## ADDENDUM

**ADDENDUM NO.:** 03  
**PROJECT NAME:** CIP Central Hearing Facility Roof and MEP Upgrades  
**PROJECT NO.:** 04044  
**CONTRACT NO.:** C1606  
**DATE OF ISSUE:** December 29, 2023

### NOTICE OF CHANGES, MODIFICATIONS, OR CLARIFICATIONS TO CONTRACT DOCUMENTS

Sheet  
**ARD-102A**

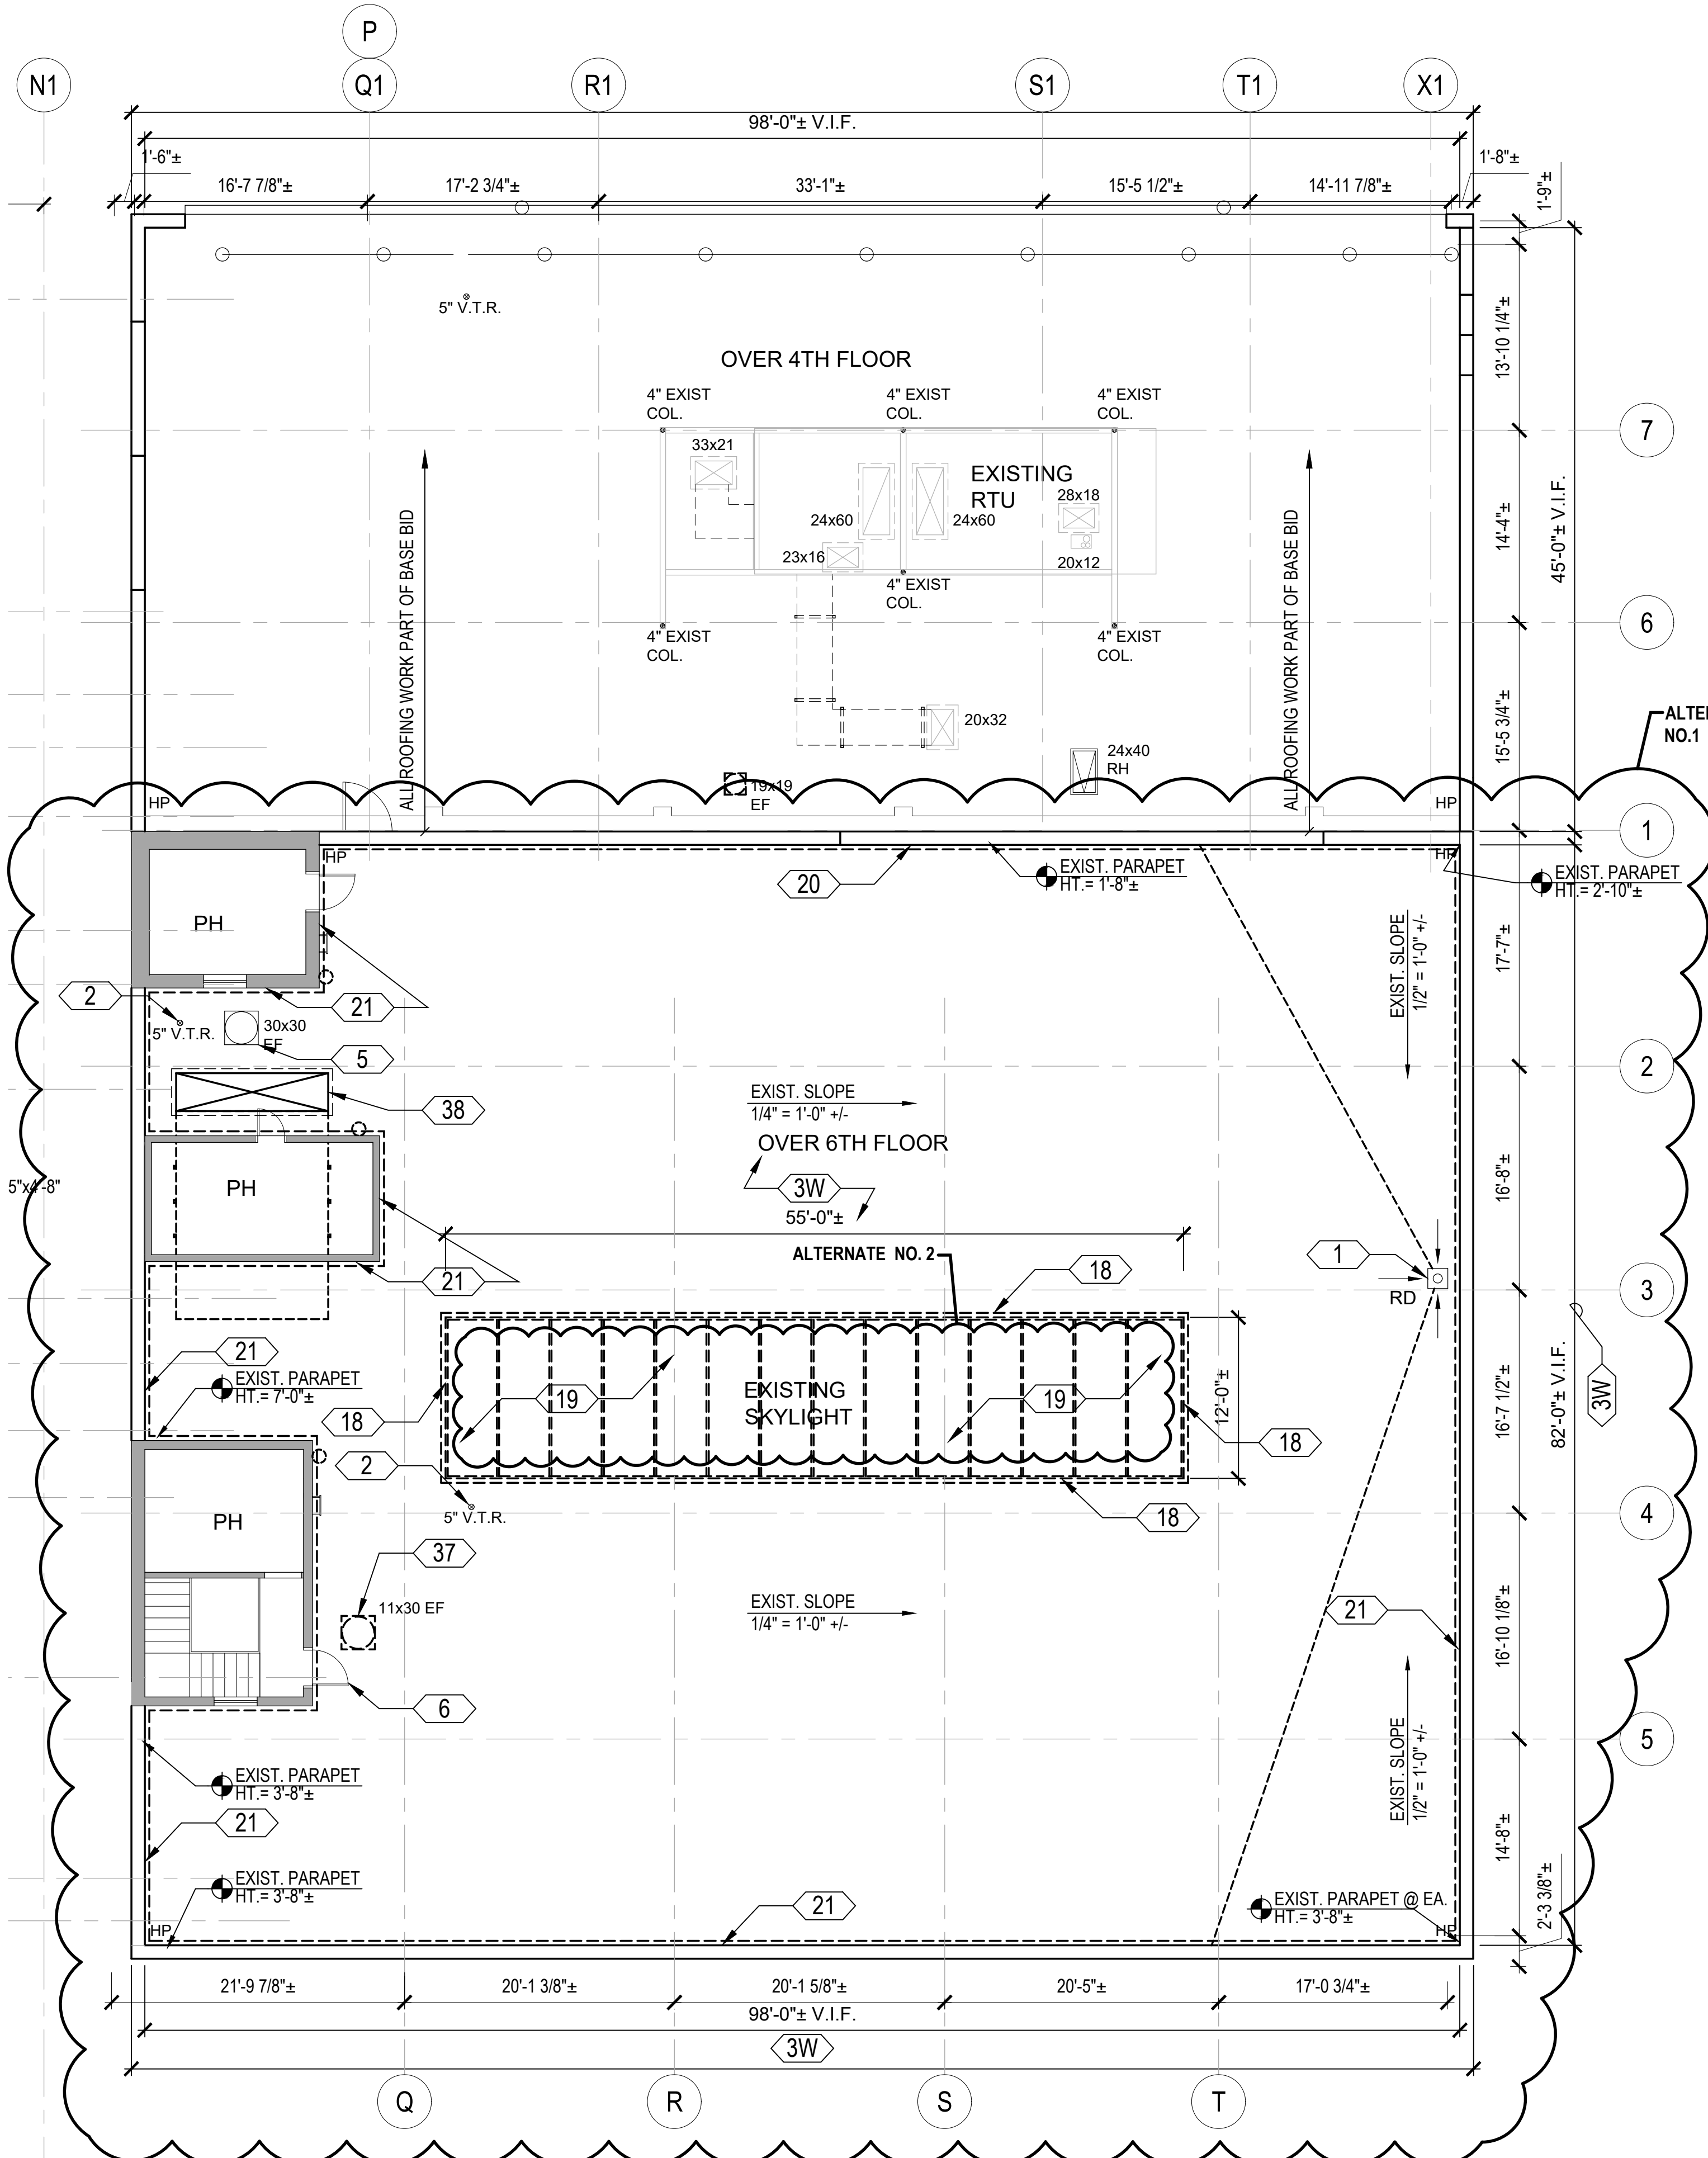
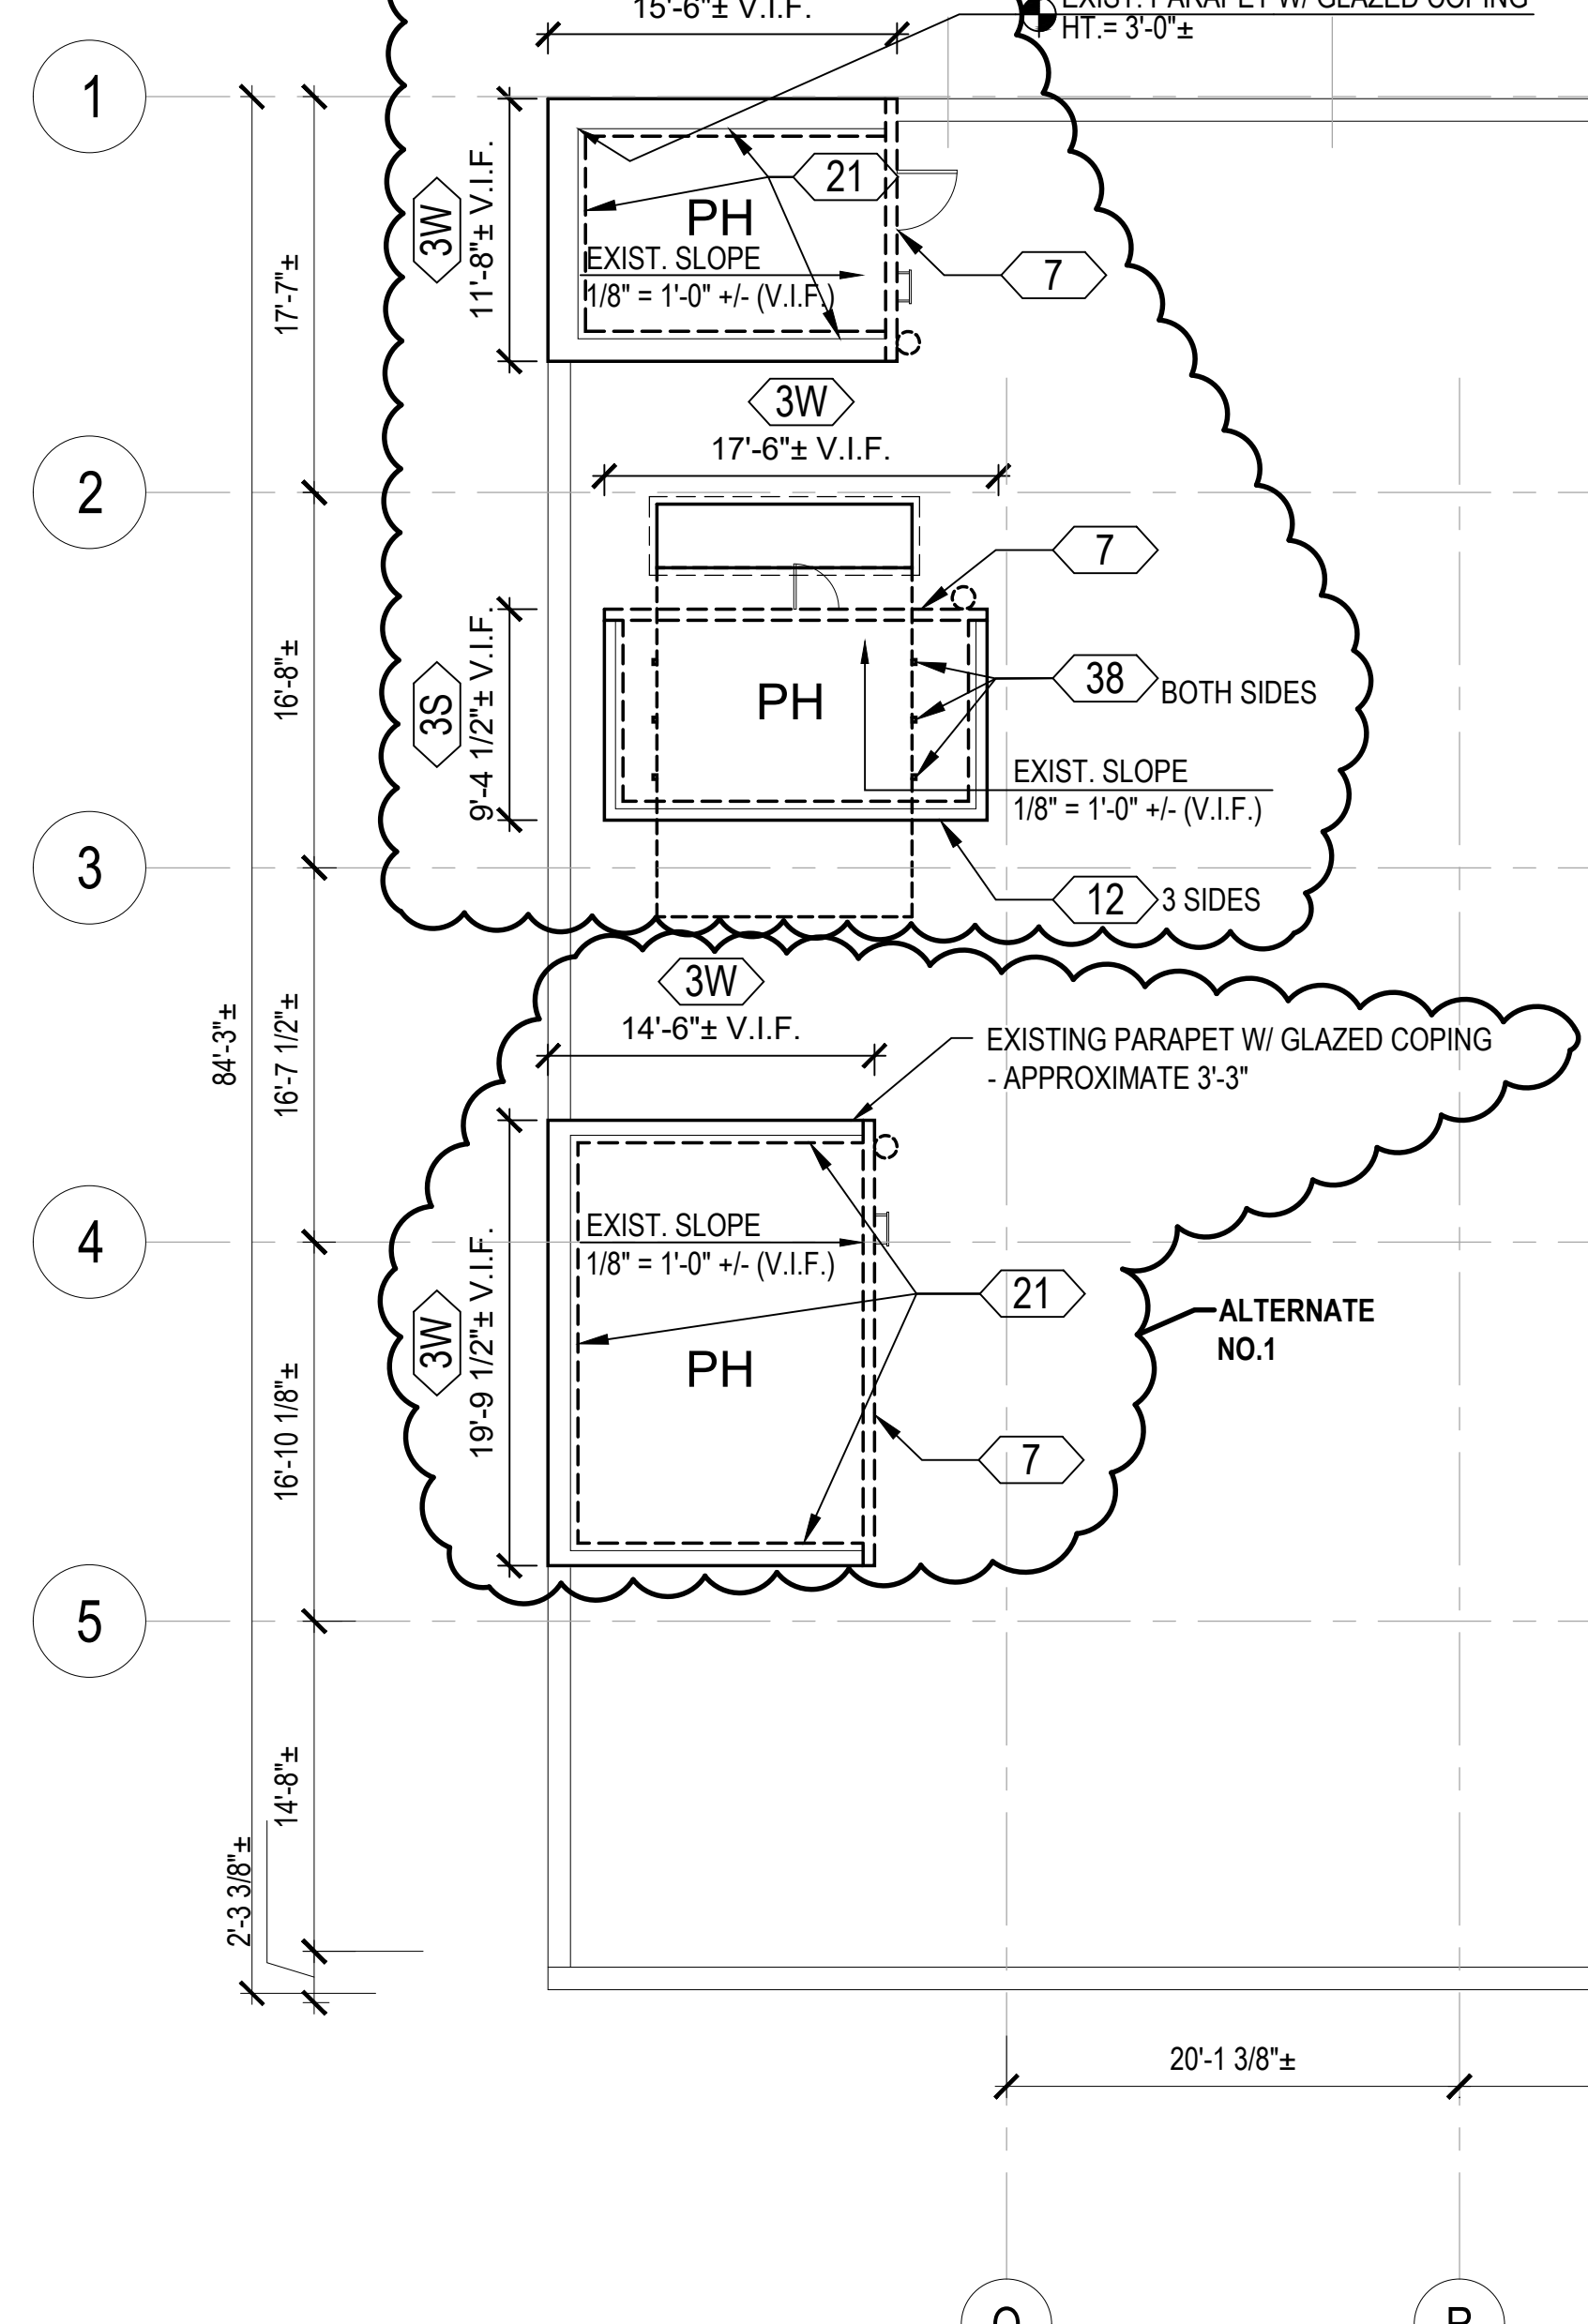
**Change 5** Drawing No. ARD-102 – **REVISED** Key Note 5, dated 12.29.23  
**Change 6** Drawing No. ARD-102A – **REVISED** Key Note 5, dated 12.29.23

PBC Project Name: CIP - Central Hearing Facility Roof and MEP Upgrades  
PBC Contract No: C1606  
Project No: 04044  
Title  
**WEST ROOF CONSTRUCTION PLAN**  
Sheet  
**AR-101**

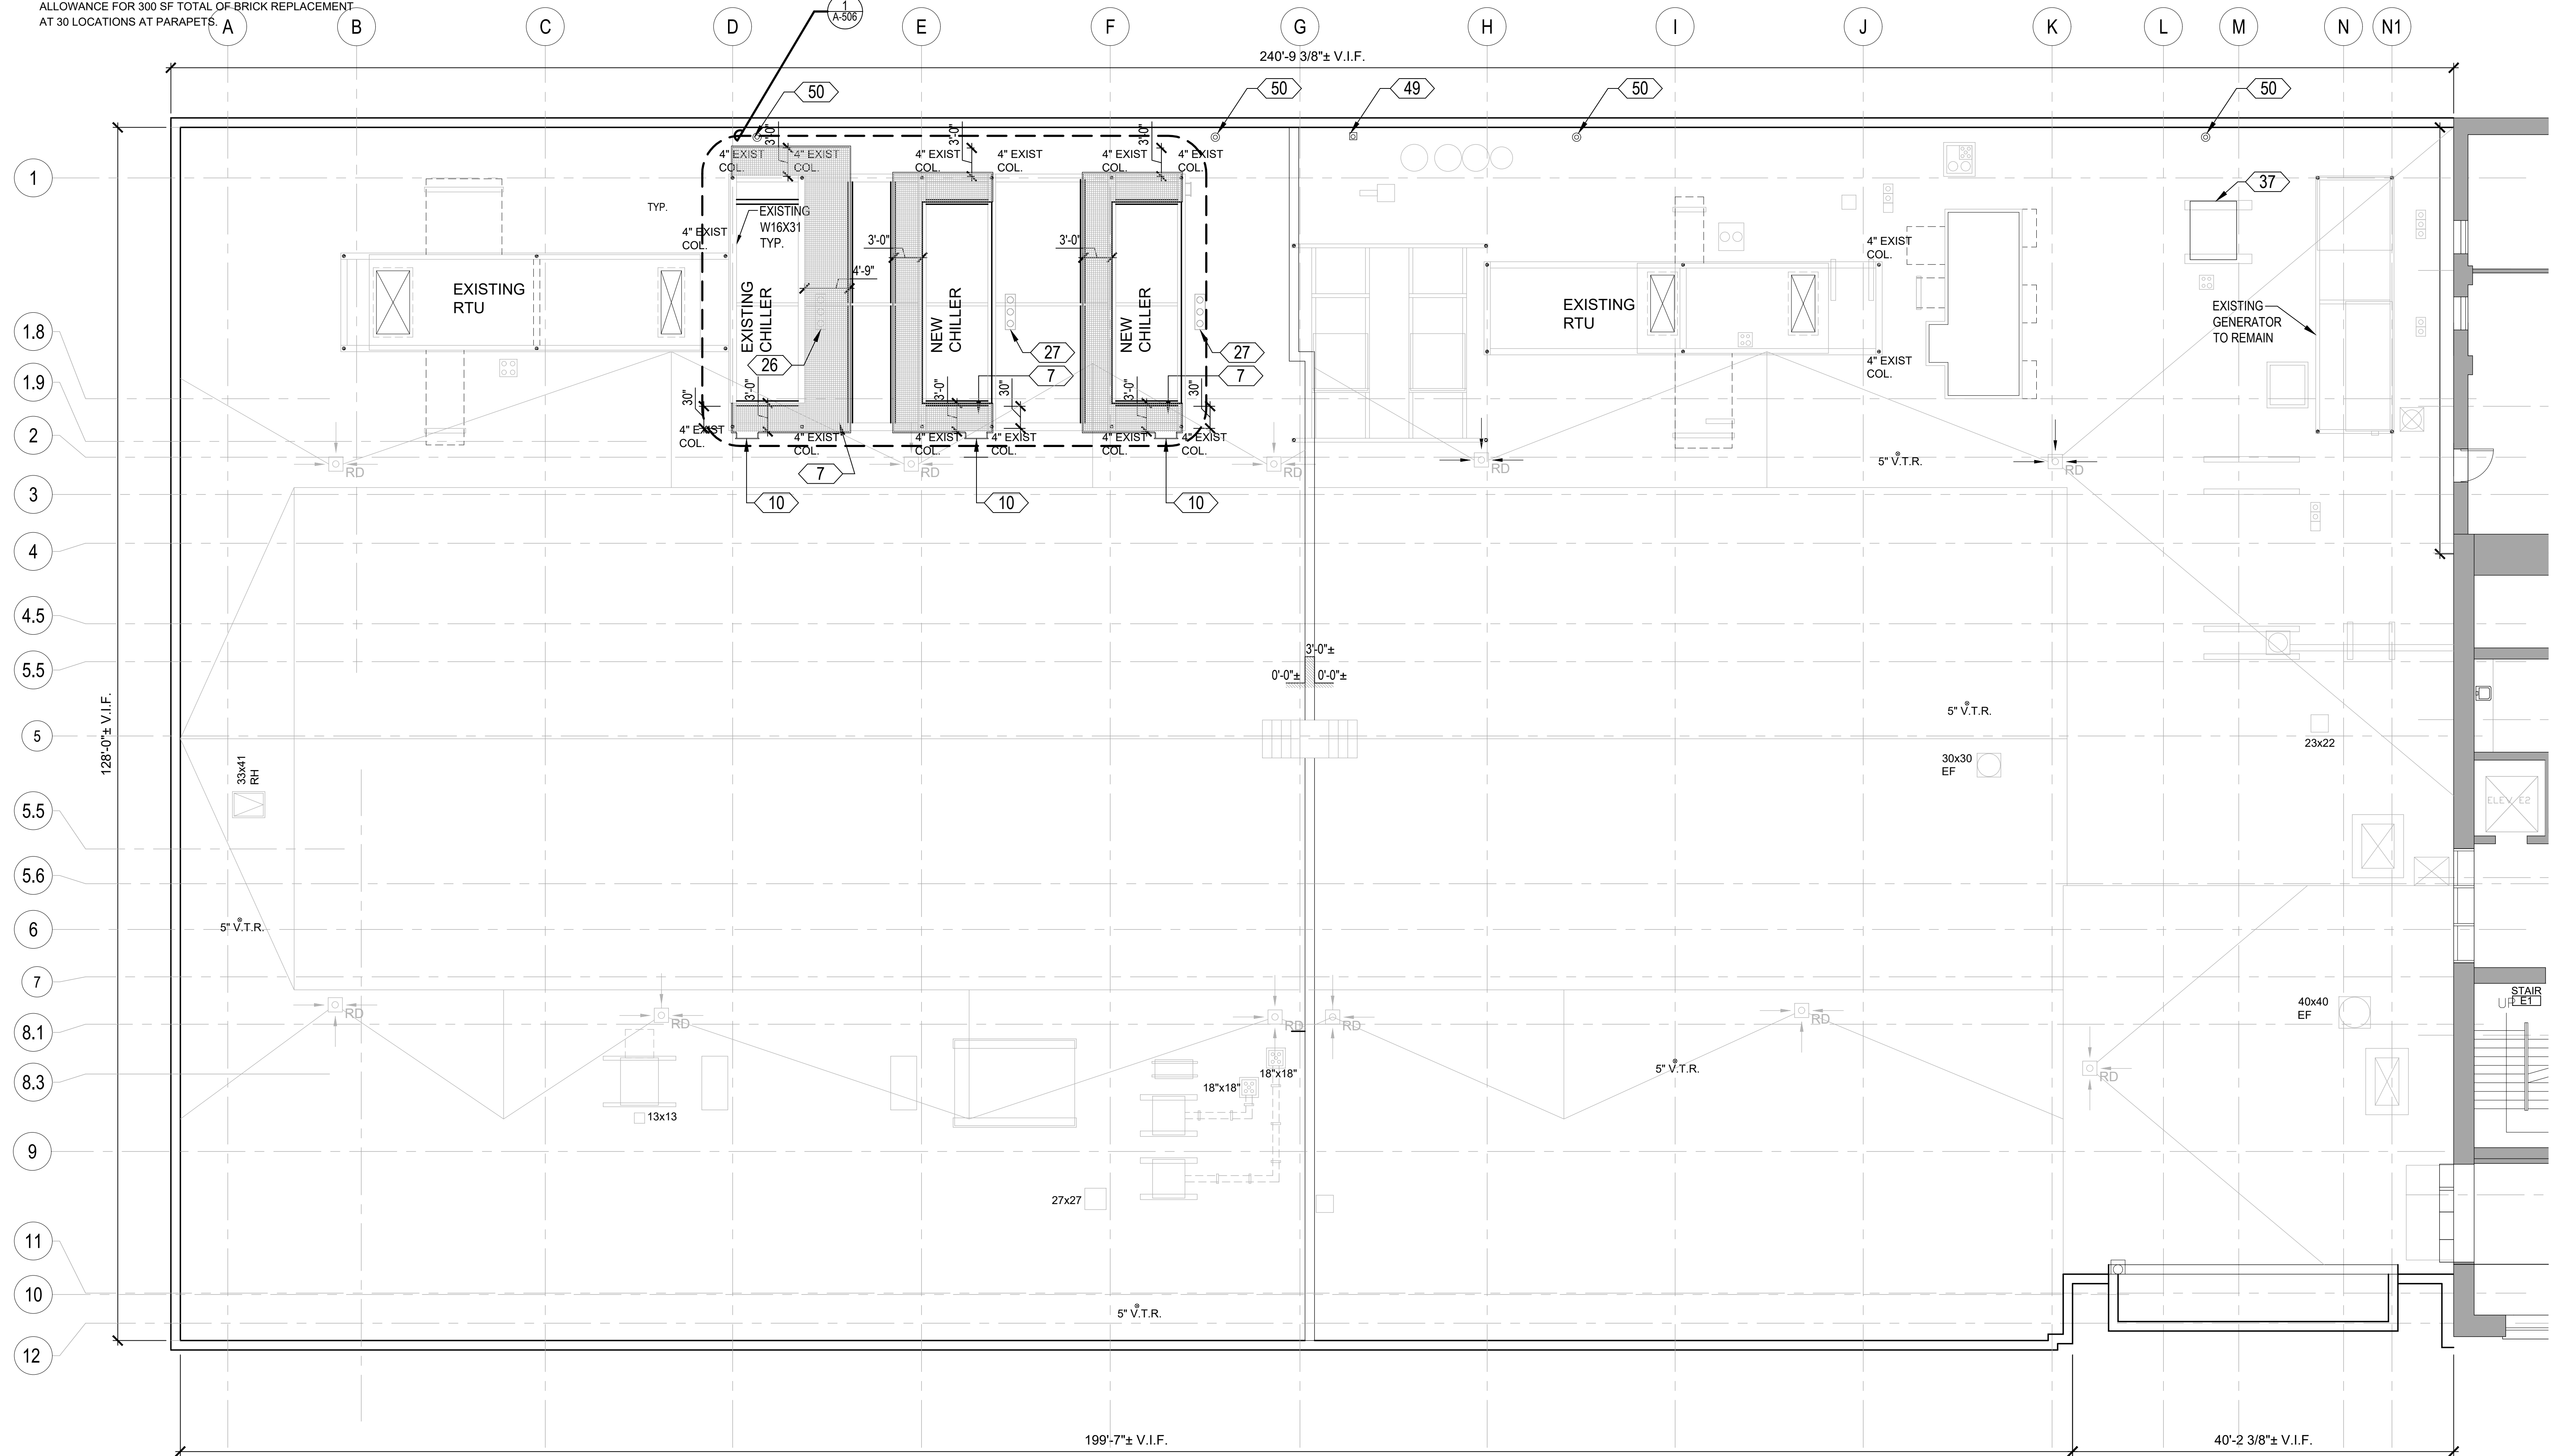
**Change 7** Drawing No. AR-101 – **REVISED** Key Notes 11, 39 and 47, dated 12.29.23  
**Change 8** Drawing No. AR-102 – **REVISED** Key Notes 11, 39 and 47; & one detail target, dated 12.29.23
